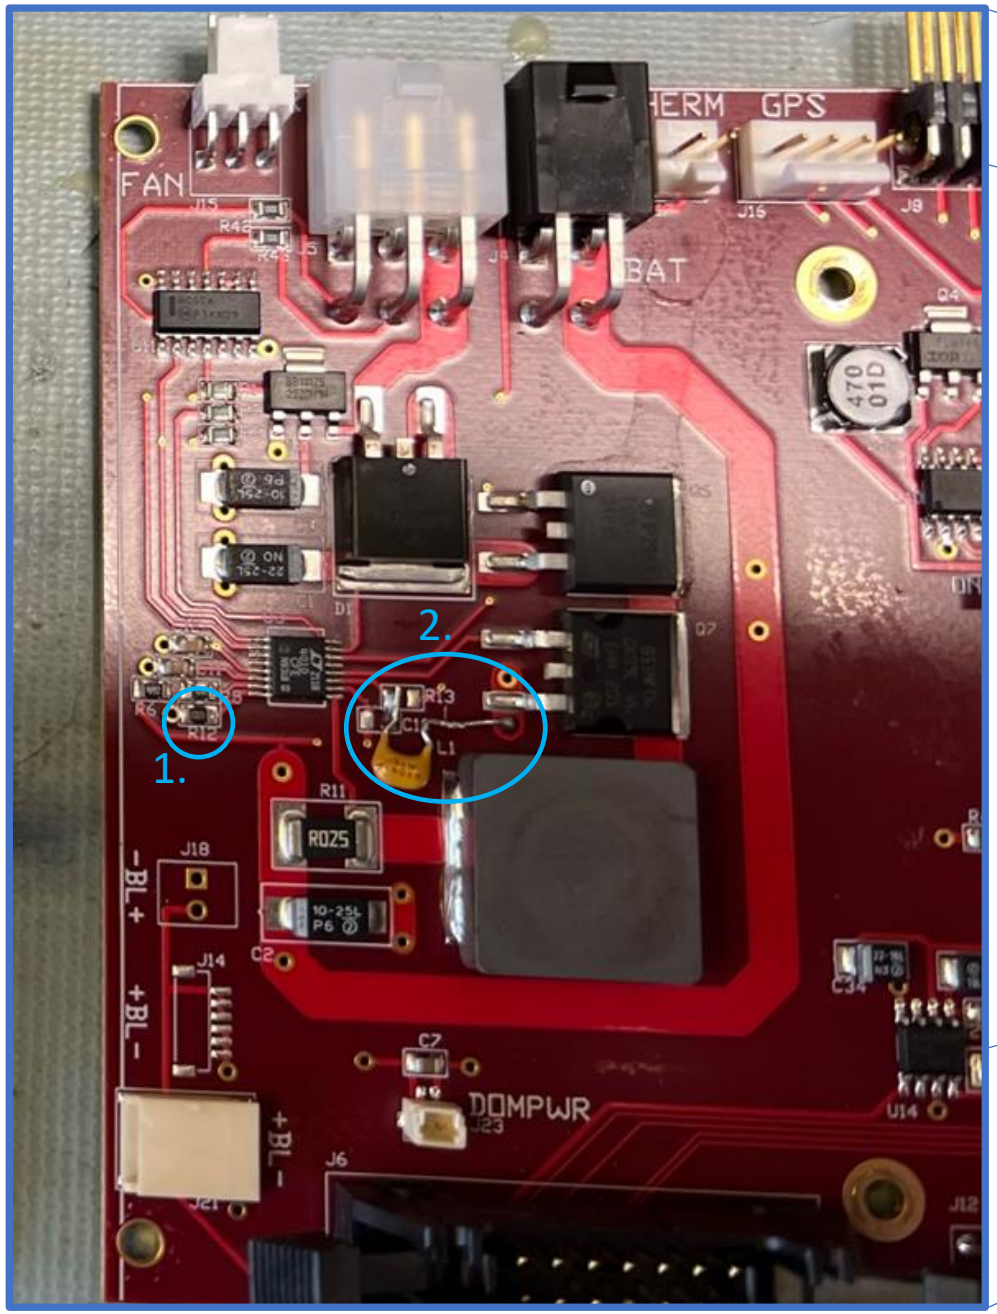
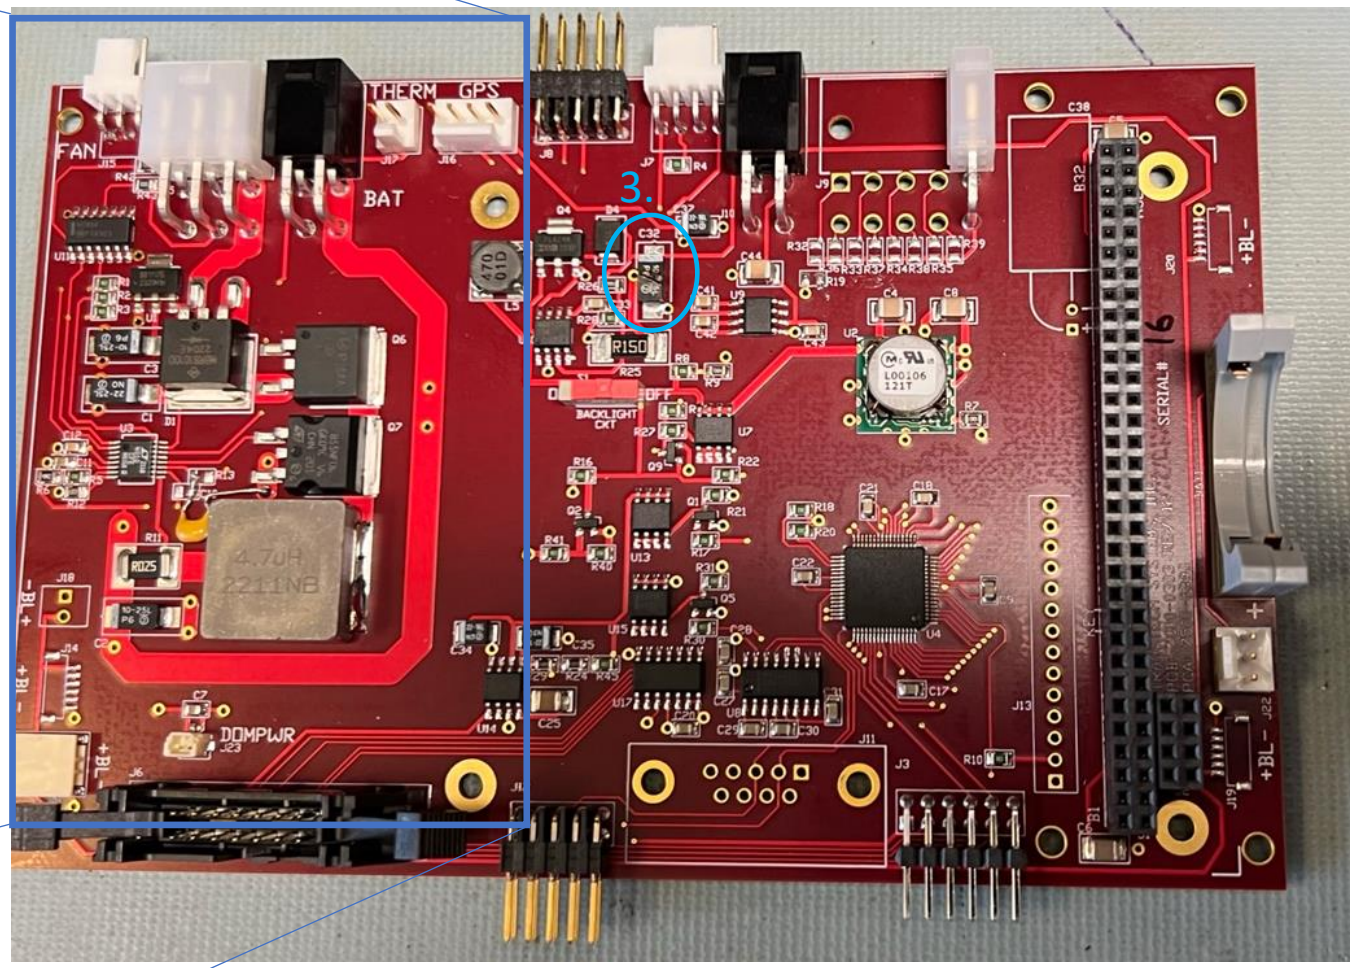
1. Remove R12
2. Remove C10 and replace with leaded component to GND
3. Replace C32 with 10uF/35V component TCJB106M035R0200
